**MPAC MEETING #3
SUMMARY NOTES**

The following is a summary of key topics from the MPAC Meeting #3:

- Chapter #3 Facility Requirement for FAA Review - Acceptance
- Runway 14/32 Dimension (10,301' x 150') *
- Runway 7/25 Dimension (5,000' x 75') *
- New Runway Scenario Concept (8,000' x 150') *
- Landside Expansion Concept(s) *

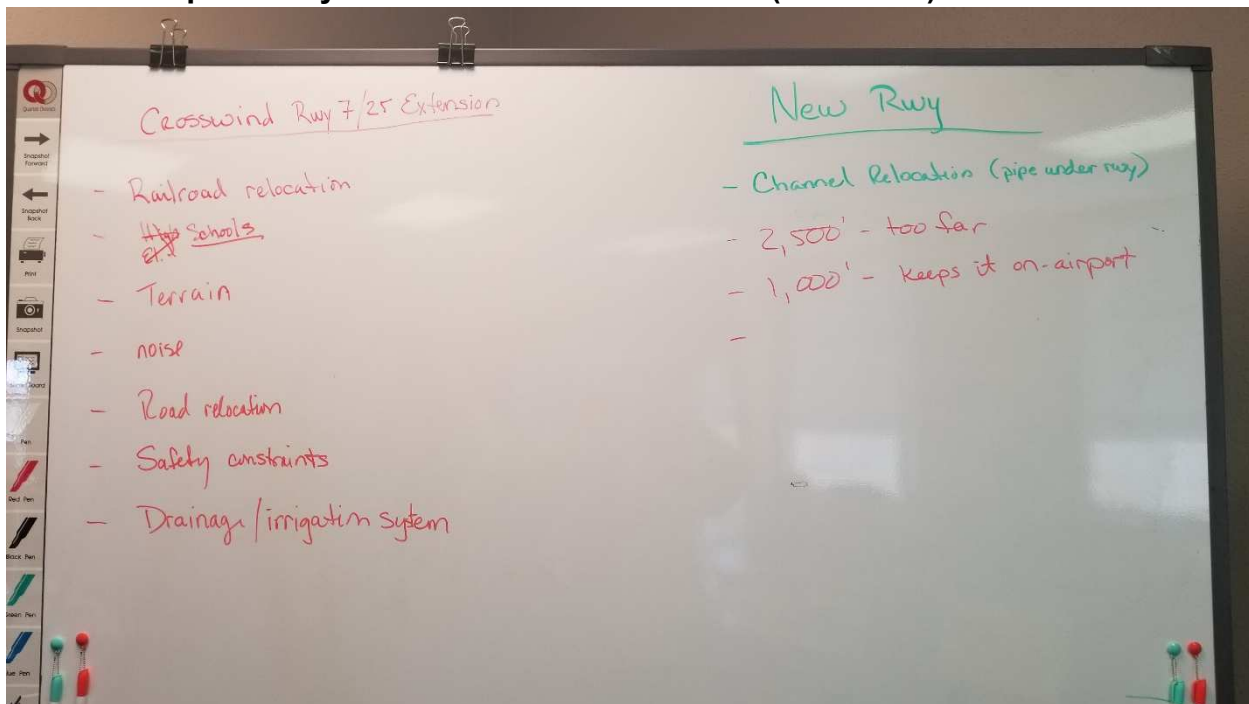
Consultant: Runway 14/32 width requirements based on D-III versus D-IV design standards. MPAC: Interest in Cascadia planes which would likely use LMT; LMT Staff indicated it would likely involve the C-17 Globemaster jet transport. MPAC: Interest in LMT serving air cargo (UPS western hub); LMT Staff indicated that some large transport aircraft are too large and heavy for LMT Runway 14/32, as pertinent with the 150-foot master plan width recommendation. Aircraft such as the Boeing 747 and C-5 Galaxy are too large to use LMT.

MPAC: LMT military activity requires 150-foot Runway 14/32 width, no exceptions.
